PCN #: 2563

PCN Title: Additional Wafer Source and Alternate Assembly Lead Frame and Clip Bond for Select Automotive Products

PRODUCT CHANGE NOTICE**PCN-2563 REV1**

Table 2 – Part Marking Format Changes

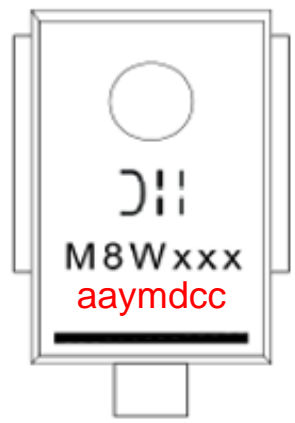
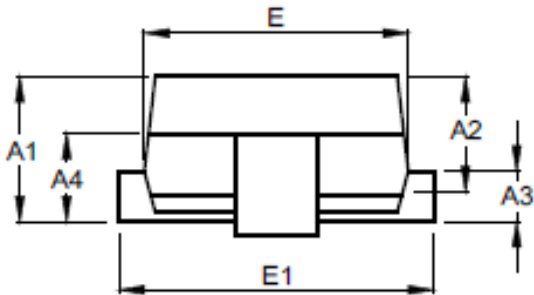
DM8WxxA(Q) marking example (Before)	DM8WxxA(Q) marking example (After)
Marking format example	Marking format example

<p>M8WxxA = Product Type Marking Code (i.e. M8W18A for DM8W18AQ-13)</p> <p>DII = Manufacturers Code Marking</p> <p>YWW = Date Code Marking</p> <p>Y = Last Digit of Year (ex: 0 for 2020)</p> <p>WW = Week Code (01 to 53)</p> <p>Bar Denotes Cathode Pin, Circle Denotes Anode</p>	<p>M8WxxA = Product Type Marking Code (i.e. M8W18A for DM8W18AQ-13)</p> <p>DII = Manufacturers Code Marking</p> <p>aa: Wafer source code</p> <p>y: Year (L=2021)</p> <p>m: Month (1 – C)</p> <p>d: Date (1 – V)</p> <p>cc: Lot serial number</p> <p>Bar Denotes Cathode Pin, Circle Denotes Anode</p>
